## ***Interactive comment on “Two fast temperature sensors for probing of the Atmospheric Boundary Layer using small Remotely Piloted Aircraft (RPA)” by N. Wildmann et al.***

Many thanks for the detailed review. In the following I will comment on each point. The referee comments will be repeated in italic before the answer.

**Fig. 1.** Schematic drawing of the complete thermocouple measurement strategy.

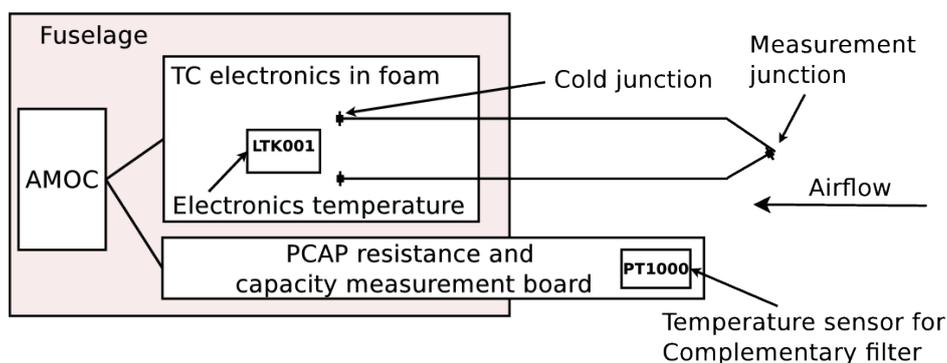
2. *caption of table 1: add "for the determination of turbulent heat fluxes" at the end of the line*  
Will be done in a revised manuscript.
3. *line 149: I suggest to use consistently RPA/RPAS instead of UAV*  
The term RPA is will consistently be used in a revised manuscript.
4. *figure 3: hard to read, in particular the very small letter size, I suggest to increase the figure or at least the fonts*

The font size was increase, see figure 1.
